NEI 17-01, Comments, Revision 6

**Industry Guideline
for Implementing
the Requirements of
10 CFR Part 54 for
Subsequent License
Renewal**

March 2017

Figure 4.2-1: Identification of AERMs

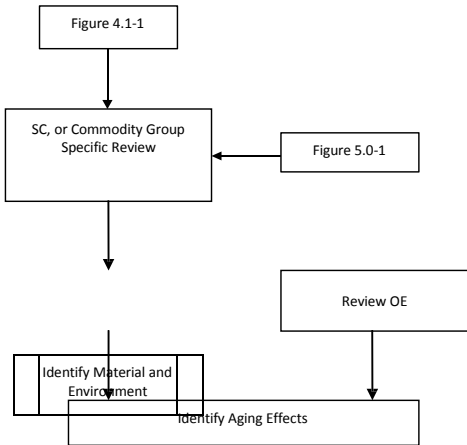
Commented [BB16]: For the steps in the middle of the flow-chart where an applicant identifies an exception to one or more program element criteria in a GALL-SLR AMP, the applicant would also have to provide a justification on why the applicant's modified GALL-SLR approach, as subsection to the identified exception or exceptions, is sufficient to demonstrate continued acceptance under the adequate aging management requirements in 10 CFR 54.21(a)(3).

Figure 4.3-1: AMP Review

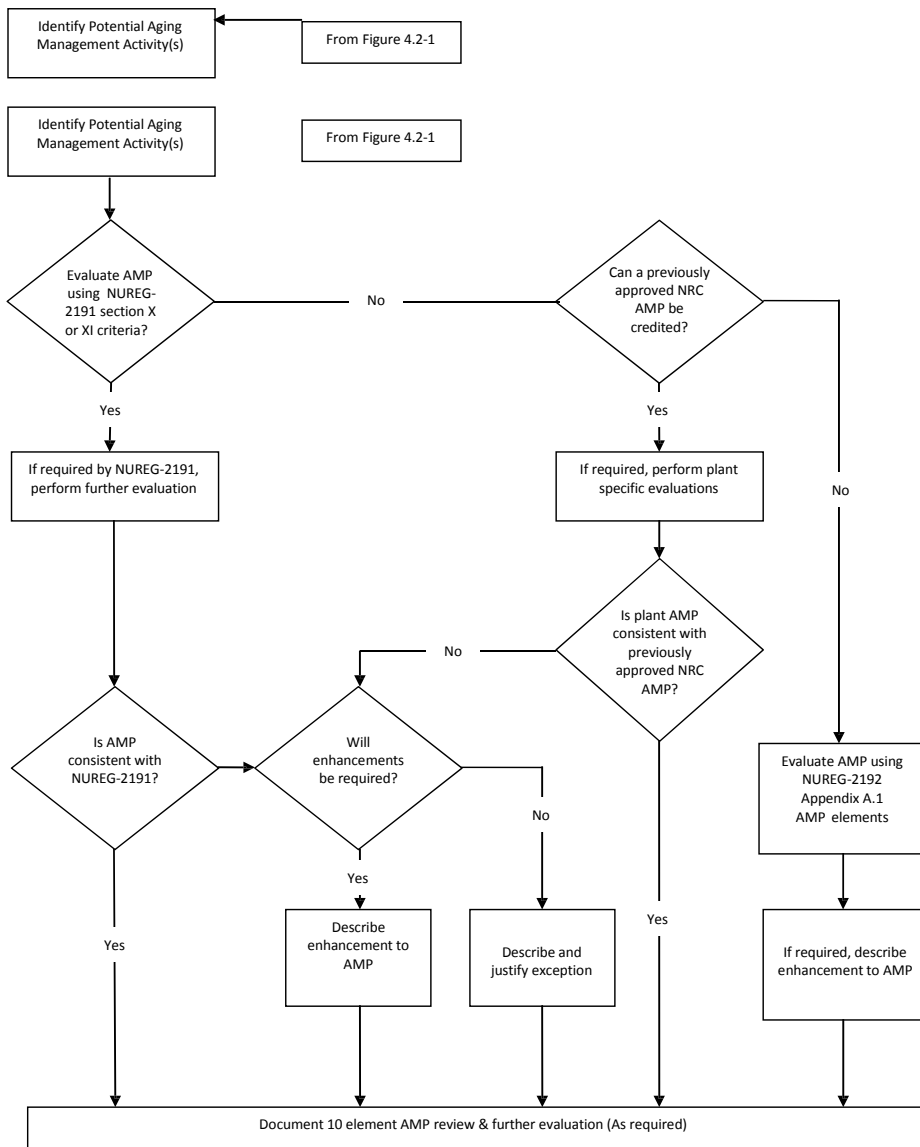
Commented [BB23]: The block "Is plant AMP consistent with previously approved NRC AMP." Is misleading. Many GALL Revision 1 and Revision 2 AMPs were revised by ISGs. The previous NRC approval may no longer be valid. Add a footnote to this block:
Previously approved AMPs might require changes based on subsequent GALL Report Revisions, Interim Staff Guidance documents, and changes incorporated in the GALL-SLR Report

This becomes more critical in Section 4.3.1 where the document discusses past precedence and other plant's SERs in relation to exceptions. Section 4.3-1 should be expanded to describe this potential error trap.

Commented [HA24]: NEI might consider changing the words to "NRC AMP for SLR" to clarify that GALL Rev. 1 and Rev 2 do not apply? The standard for comparison is to GALL-SLR AMPs only.

Figure 5.0-1: Evaluation of TLAAs and Exemptions [§ 54.21(c)]

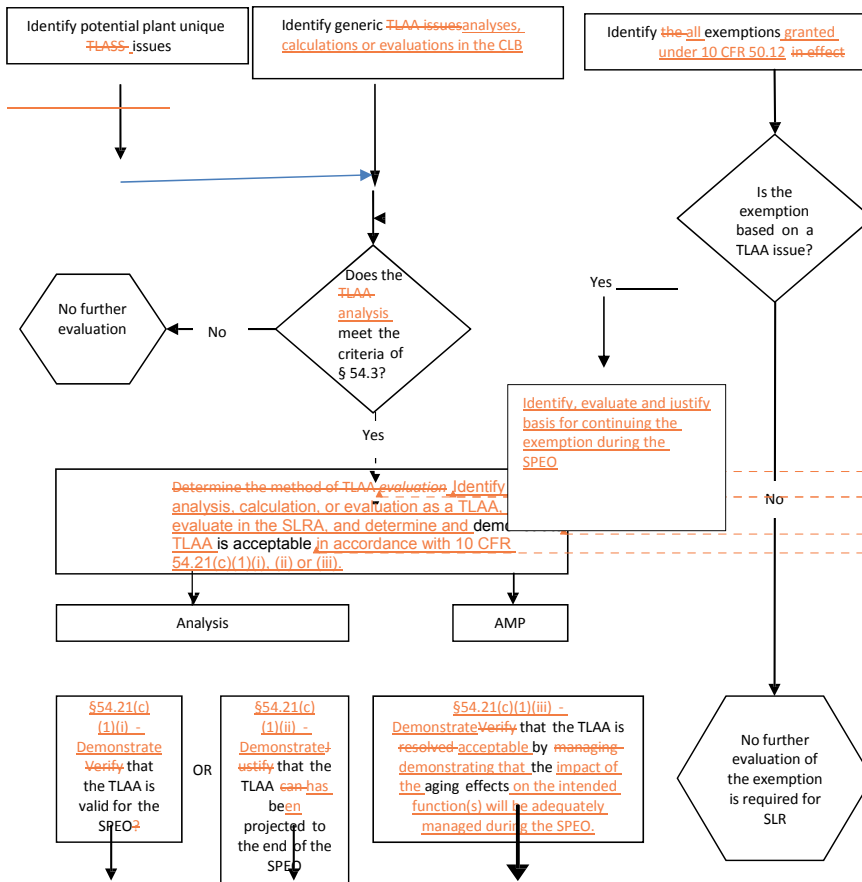
Commented [BB33]: The staff has a number of issues with the flow chart and recommends some changes to it.
